PIC18F6520/8520 Rev. A1 Silicon/Data Sheet Errata

The PIC18F6520/8520 Rev. A1 parts you have received conform functionally to the Device Data Sheet (DS39609B), except for the anomalies described below. All the issues listed here will be addressed in future revisions of the PIC18F6520/8520 silicon.

FIGURE 11-1: TIMER0 BLOCK DIAGRAM IN 8-BIT MODE

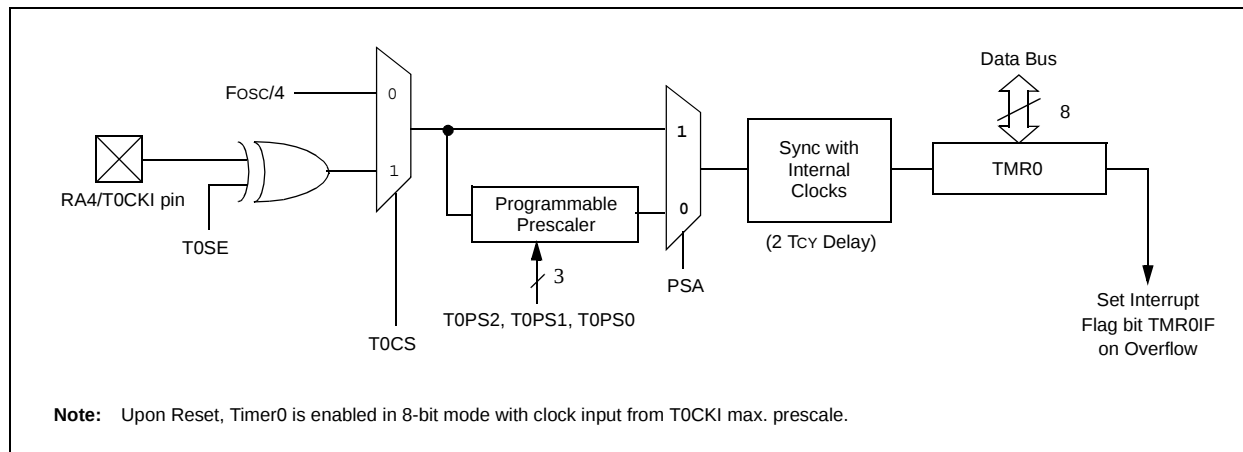
In Figure 11-1 and Figure 11-2 of the Device Data Sheet, the Timer0 Prescaler Assignment (PSA) bits are incorrectly stated. To remedy this, the bit values have been swapped as shown in the figures below.

FIGURE 26-1: PIC18F6520/8520 VOLTAGE-FREQUENCY GRAPH (INDUSTRIAL, EXTENDED)

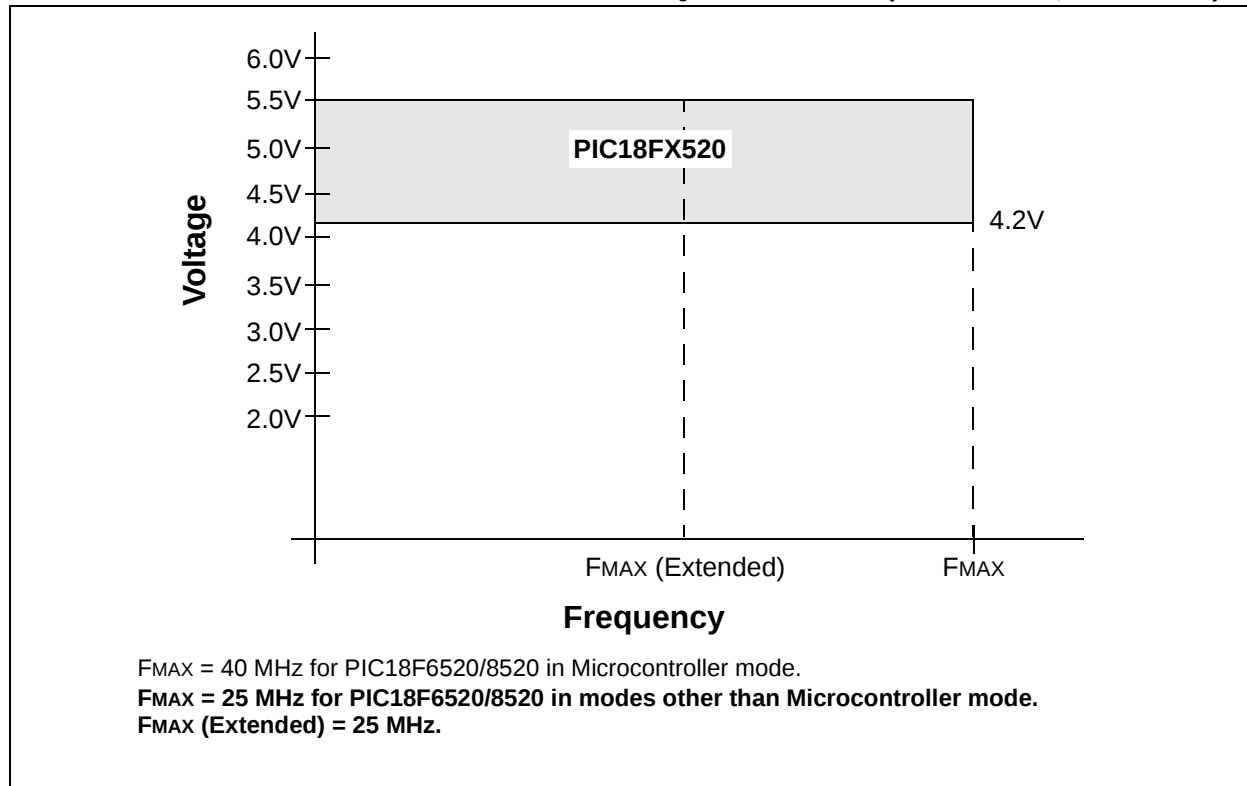
In Section 26.0 “Electrical Characteristics”, Figure 26-1 has been updated to clarify the voltage frequency for Industrial and Extended devices.
